## Charlotte-Mecklenburg Historic Landmarks Commission

### Historic Landmarks Department Staff Report – January 12, 2026

Landmark Name:	The Fidler House
Landmark Address:	21112 Catawba Avenue
City State Zip:	Cornelius, NC 28031
Applicant Name:	Jonathan Hutchinson
Item:	HLC527

2  
A1.1  
PROPOSED FRONT ELEVATION  
NTS

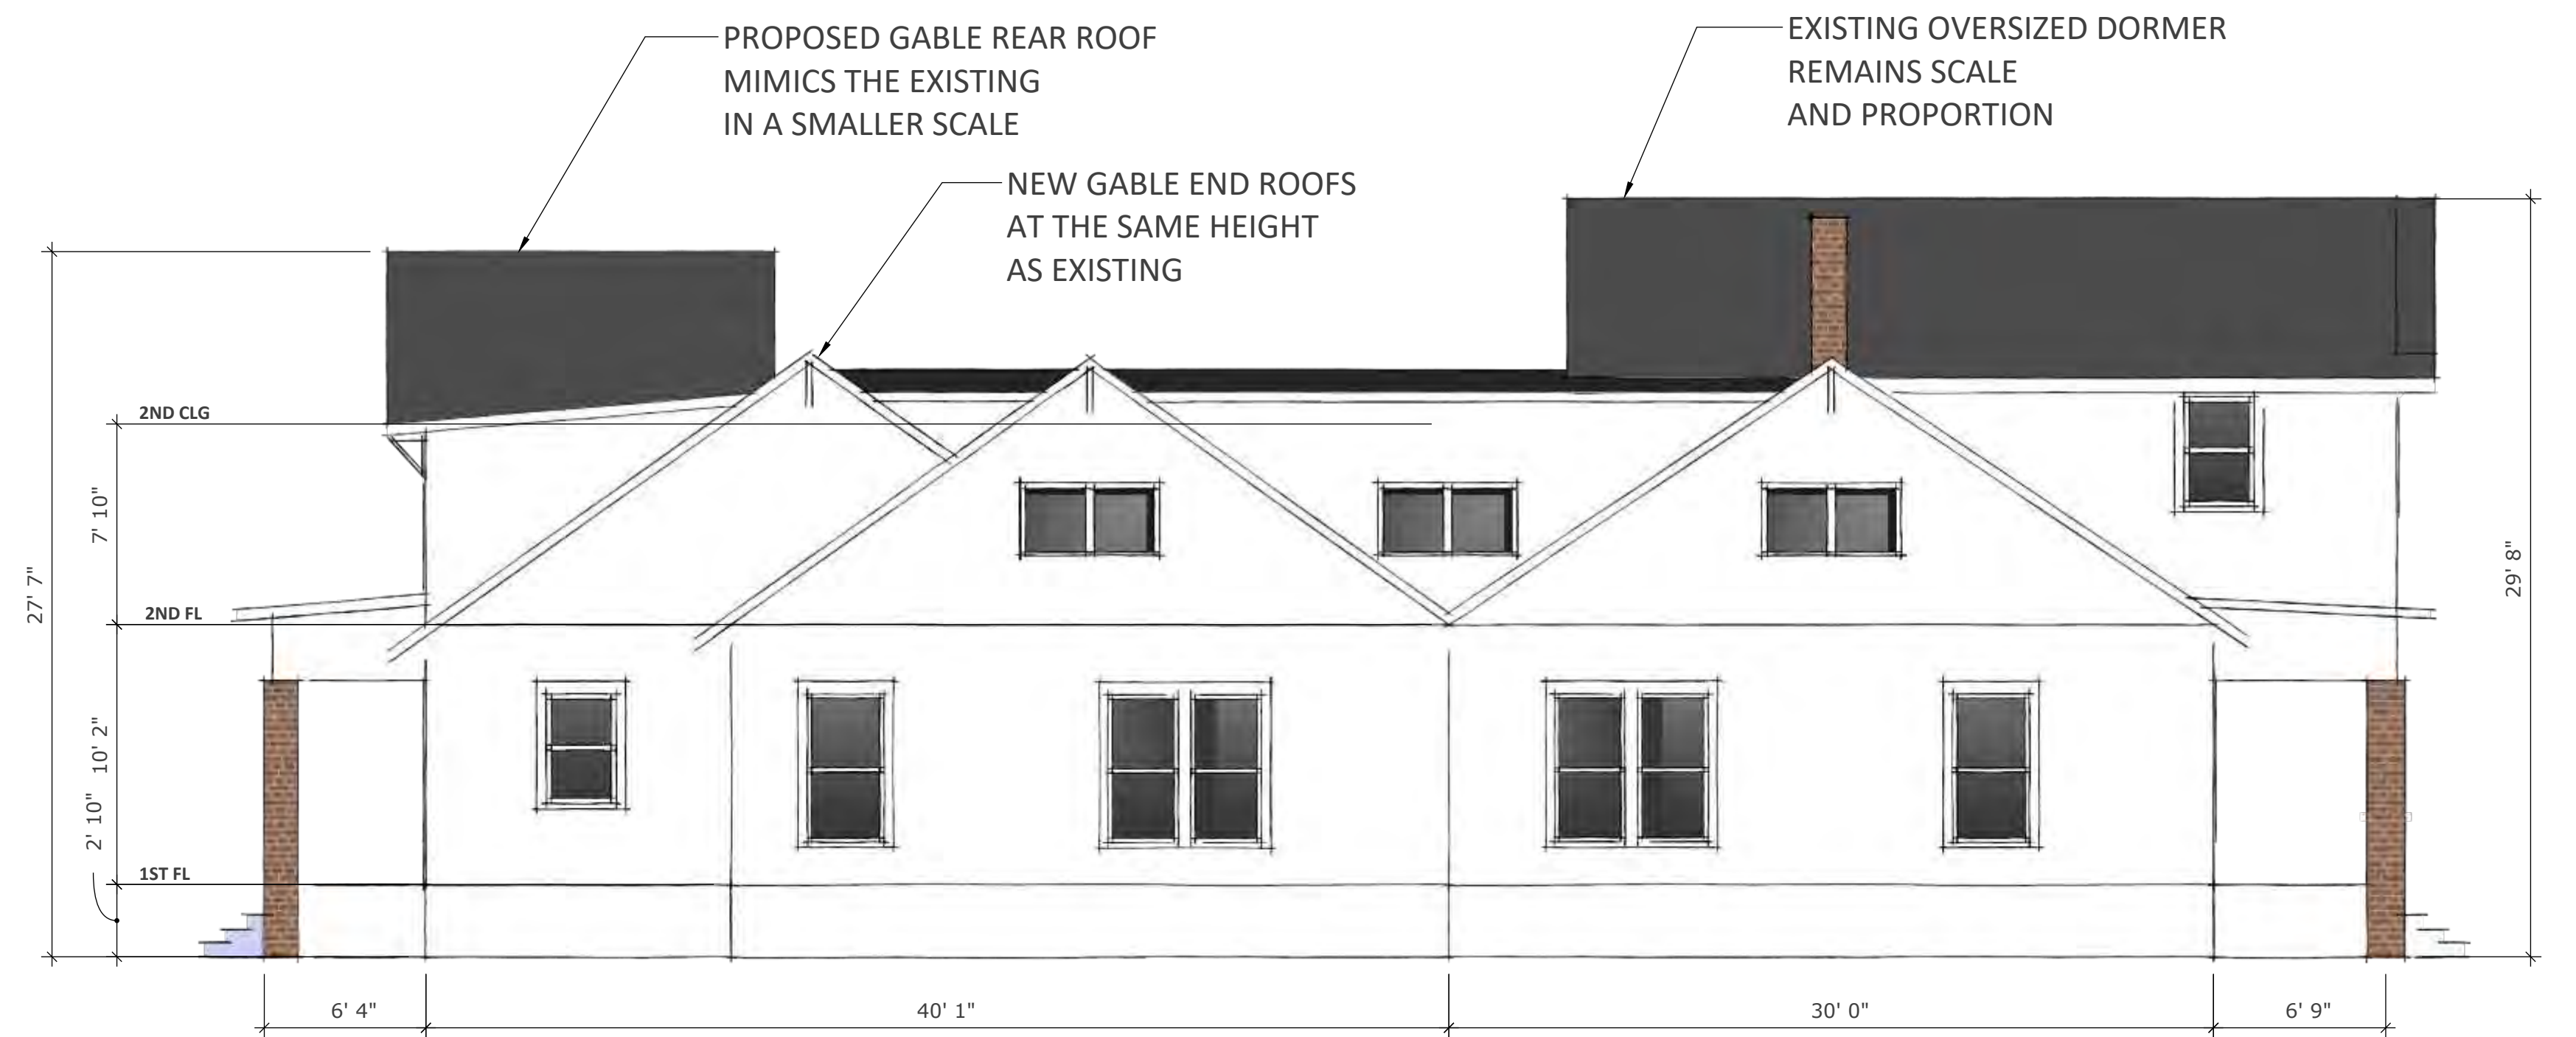
2. The historic character of a property shall be retained and preserved. The removal of historic materials or alteration of features and spaces that characterize a property shall be avoided. **Character defining elements on the front and side elevations would not be altered (original windows, front dormer, eave brackets, materials). Rear dormer elevation windows would be removed.**

The proposal meets the Standards for height, width, and materials. However, the new addition directly behind the original building is coplanar and the rhythm of the side elevation is disrupted by the rear dormer over the porch. The twin side gable roofs and wall planes are flush with the original building making it difficult to differentiate new construction from the original side elevations.

Staff does not recommend approval, *as submitted*, due to conflicts with Standard 9 as noted.
